Dawn
Coral PWV28#24

ADMINISTRATIVE APPLICATION CHECKLIST

Re: CORAL PLU 28 #2H
NSL

Re: Coral PWU 28 #2H
Section 28-T19S-R29E
Eddy County, NM

WELL LOCATION AND ACREAGE DEDICATION PLAT

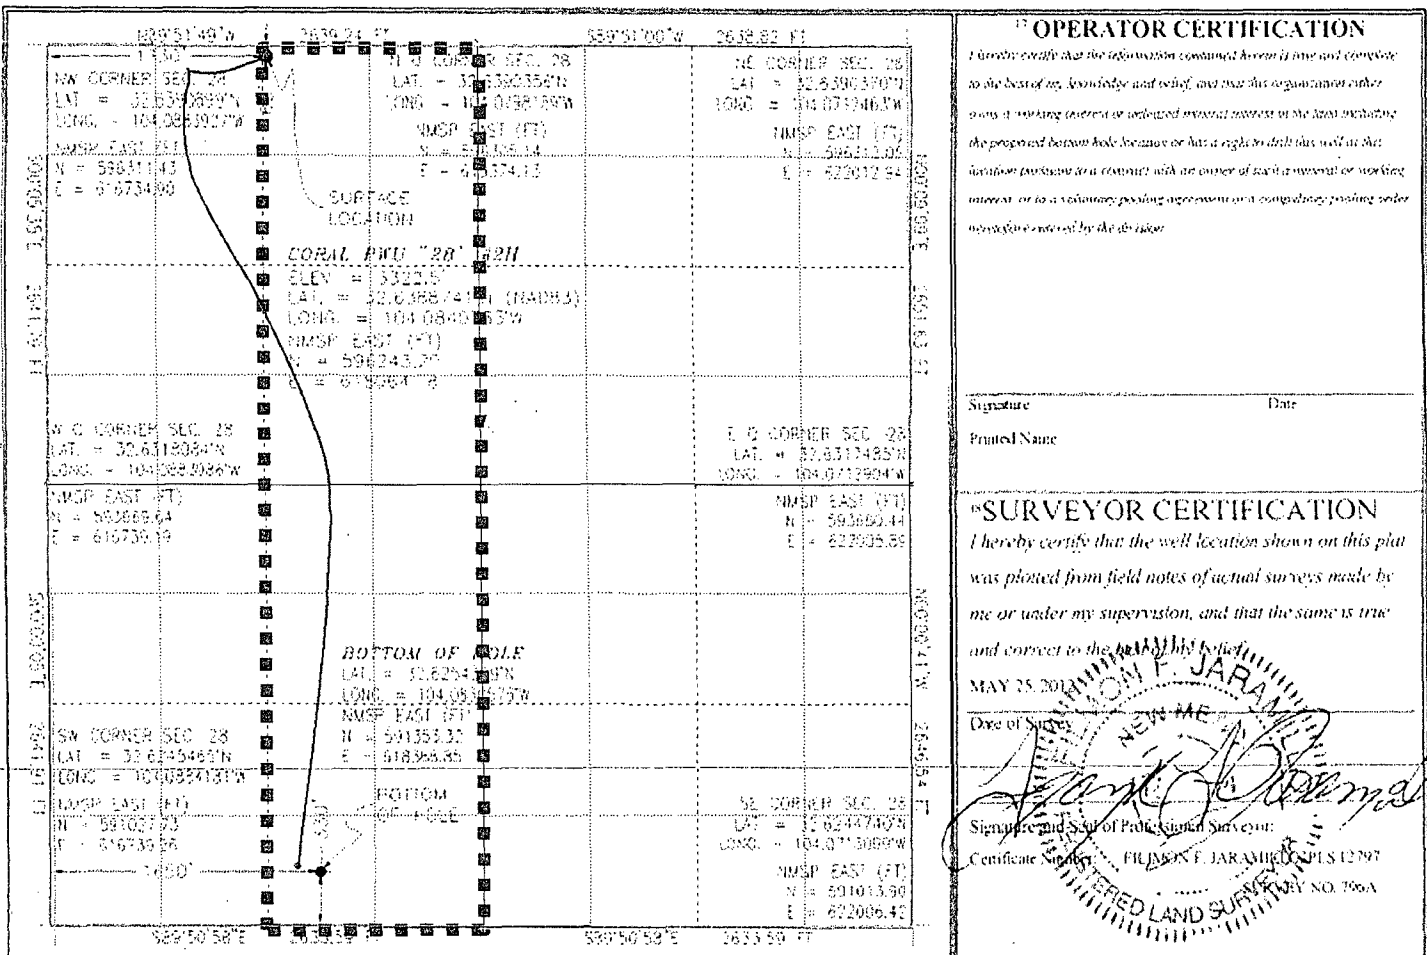
I do have a question, however. The indicated bottom perf location appears to be 458 feet from the NW corner of the project area. Since it is less than 467 feet from the corner, we need to address the issue of ownership of the unit to the northwest (presumably Unit M of Section 21), as well as the units to the west.

Please advise regarding ownership status of the unit to the northwest.

TC 11/21/12 clarified that encroachment is at SW corner toward Def. 33.
